Grand Promenade, JSP14-15

Public hearing at the request of Novi Promenade Holdings LLC for Special Land Use Permit, Preliminary Site Plan, Wetland Permit, Woodland Permit, and Stormwater Management Plan approval. The subject property is located in Section 17, on the south side of Grand River Avenue at Twelve Mile Road in the B-3, General Business District. The subject property is approximately 2.56 acres and the applicant is proposing an 11,970 square foot retail space and 3,817 square foot drive-through restaurant.

Revised Preliminary Site Plan and Special Land Use

SUBJECT: Grand Promenade, JSP14-0015, Traffic Review of Revised Preliminary Site Plan and Revised Traffic Impact Study, PSP14-0134

Date: 6-30-14
Drawn By: MD
P.E. - MATT DEFFIN
SCALE: 1 inch = 30 ft.
JOB No.: 130396
Sheet No.:
3 OF 7

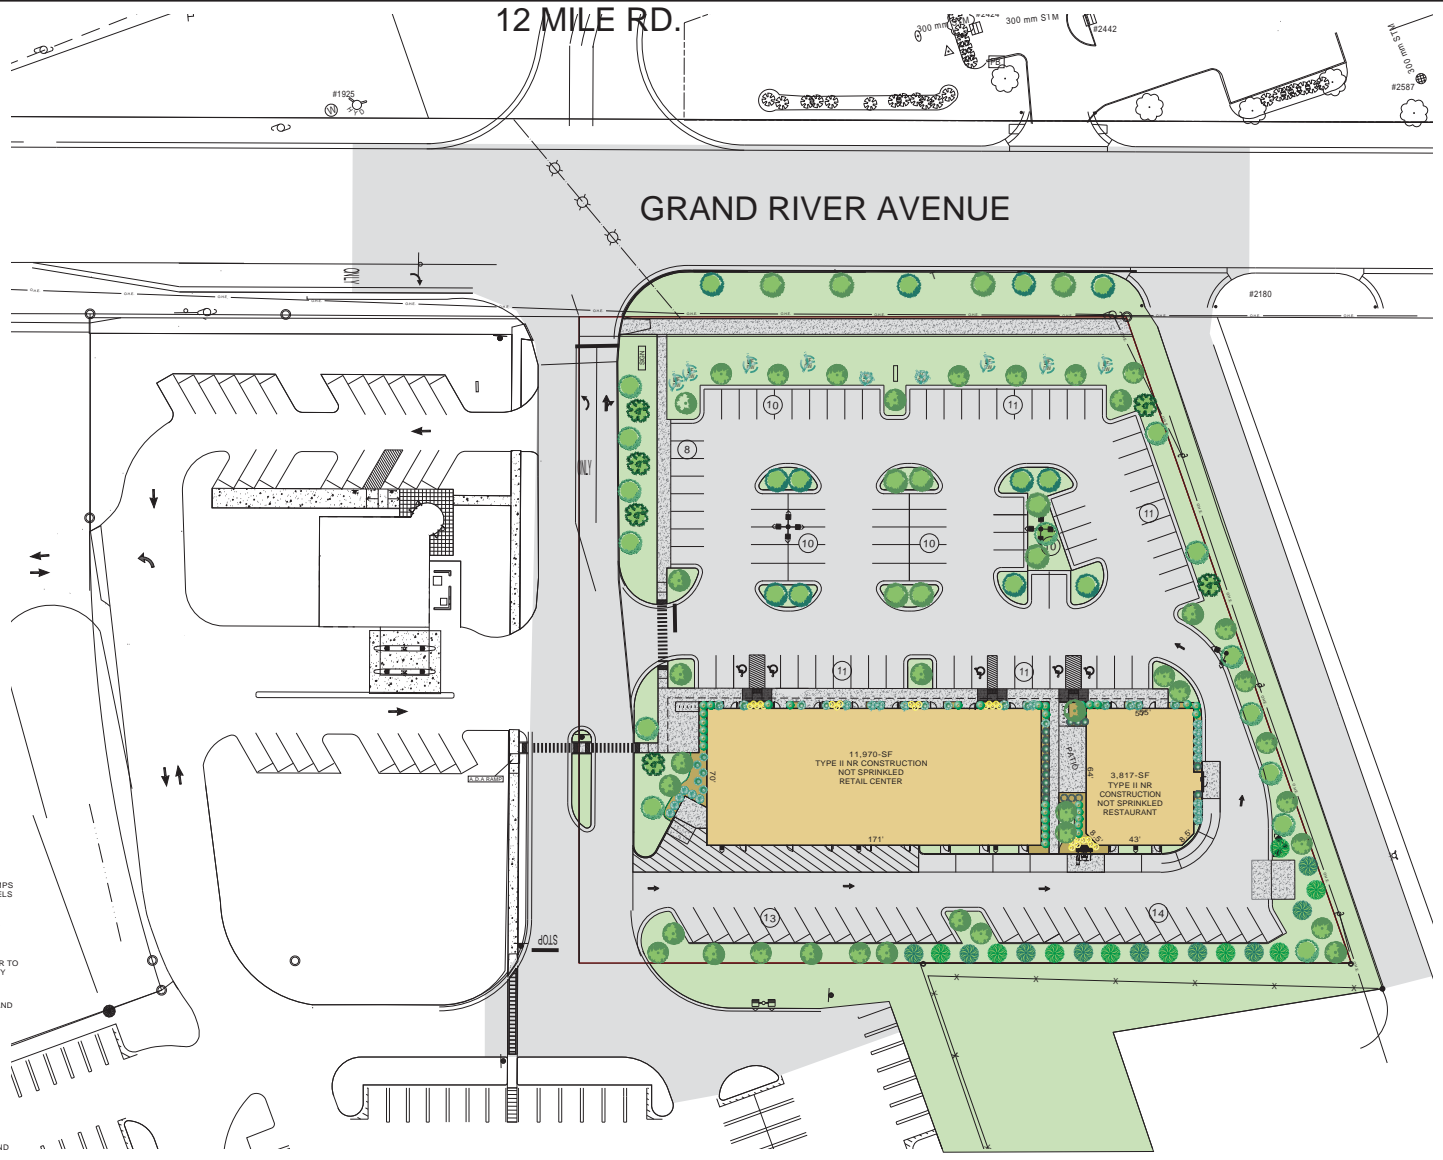
8. End parking spaces scale 9 ft wide to the lip of gutter rather than to the face of curb. **The applicant should be asked to justify the extra 1.5 ft of impervious surface being proposed as a result of the proposed design. We recommend that these spaces be narrowed to 9 ft to face of curb (per customary practice) and so-noted. Also, to better facilitate future reviews, all curb and gutter should be illustrated in the conventional three-line manner (i.e., with a line added to represent the face of curb).**

9. The symmetric end islands in the interior of the parking lot scale 30 ft long (back-of-curb to back-of-curb), rather than the 32 ft we asked for in our last letter. The applicant is correct in stating that the Zoning Ordinance "Sec. 2506.13 details online show 30 ft..."; however, the text of that section states that such islands "shall generally be constructed three (3) feet shorter than the adjacent parking stall..." Novi-standard interior parking stalls are now 19 ft long rather than the 18 ft prevailing when this detail was originally drawn (and the detail was not updated until the recent drafting of the Clearzoning ordinance). Hence, **the text specifications result in the standard island now being 32 ft long rather than 30 ft long. It should be noted that Sec 200 of the ordinance states: "In the case of any difference of meaning or implication between the text of this Ordinance and any caption or illustration, the text shall control."**

10. The large landscape island now proposed near the east end of the north lot would have 17-ft-long parking stalls on its east and west faces and 19-ft-long parking stalls on its south face. The shorter stalls are encouraged, but (per Sec 2509.3c(2)(c)) they must abut a 4-inch-high curb. Elevations on the proposed Utility/Grading Plan (sheet 4) indicate that the curb on this island would be 6 inches high rather than 4 inches. **This island should be redesigned to feature 17-ft-long parking stalls on all three sides, and both sheet 3 and sheet 4 should indicate that the island's curb will be 4 inches high.**

13. The 18-ft length dimension provided for a typical rear parking stall should extend behind the curb to indicate the assumed vehicle overhang of 2 ft (a correct 16-ft dimension to face of curb appears nearby).

14. In the lower left-hand corner of sheet 3, the long note specifying the colors of pavement markings should (a) reduce the width of the loading zone crosshatching to 4" (from 12") and (b) add a final sentence reading "See parking space detail on sheet 7." Then, in the cited detail on sheet 7, the blue and white lines separating a handicapped stall from a non-handicapped stall should be shown directly abutting each other; this will require the use of different shadings for the two colors. (Pavement marking illustrations must be drawn as literally as reasonably possible, since they are illustrating what is to be installed.)

15. All references to proposed NO PARKING FIRE LANE signs have been removed from the plan. Subject to the advice of the City's Fire Marshal, **we recommend that three such signs be proposed along the east egress from the rear parking lot: one on each side of this one-way drive near the northeast corner of the restaurant, and a third on the east side of the drive 75 ft to the south. Assuming such signs are added, they must also appear in the Sign Table (but not with the incorrect sign code as was done earlier).**
